FOUNDATION MODIFICATION 9715 RUBICON DR ADO SPRINGS, COLORADO SAINT AUBYN HOMES COLORADO ARCH/ENG: RAG DRAWN: RSR CHECKED: DHS

JOB NO. 163730

Re: Structural Modification – Garage Holdown

9715 Rubicon Dr Model 1542.2

PARTIAL FOUNDATION PLAN

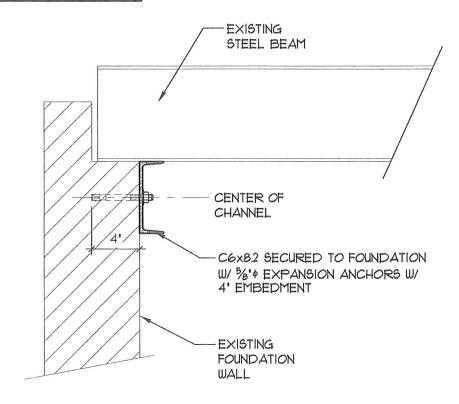
THIS PLAN IS TO ADD REINFORCEMENT AT BEAM POCKETS ONLY -REFER TO ARCHITECTURAL PLANS BY TERRY C. DESIGN SERVICES FOR MODEL 15422 LAST DATED 9-14-16 AND FOUNDATION DESIGN FOR MASTER 15422 BY ROCKY MOUNTAIN GROUP JOB NO. 154654 LAST DATED 9-21-16 FOR ALL OTHER INFORMATION NOT SHOWN HERE.

DETAIL

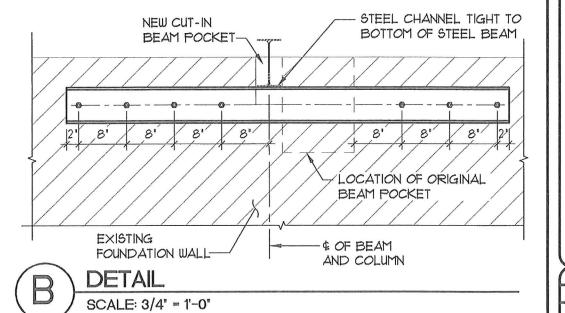
The Simpson STHD14 holdown to the immediate right of the garage opening was installed with inadequate embedment depth and appeared damaged. A Simpson HTT5 holdown may be installed against the interior face of the wall at this location. The base of the new holdown should be installed directly on the foundation wall. The holdown should be fastened to a minimum (2) 2x4 full height post in the wall framing with 16d nails. The contractor should drill and epoxy a new 5/8" diameter ASTM A307 threaded rod anchor at the holdown. The new anchor should be embedded into the concrete a minimum of five inches with Simpson SET-XP epoxy (2-1/2" min. edge distance). The contractor should locate and avoid existing concrete reinforcing prior to drilling. See the manufacturer's specifications for proper installation procedures.
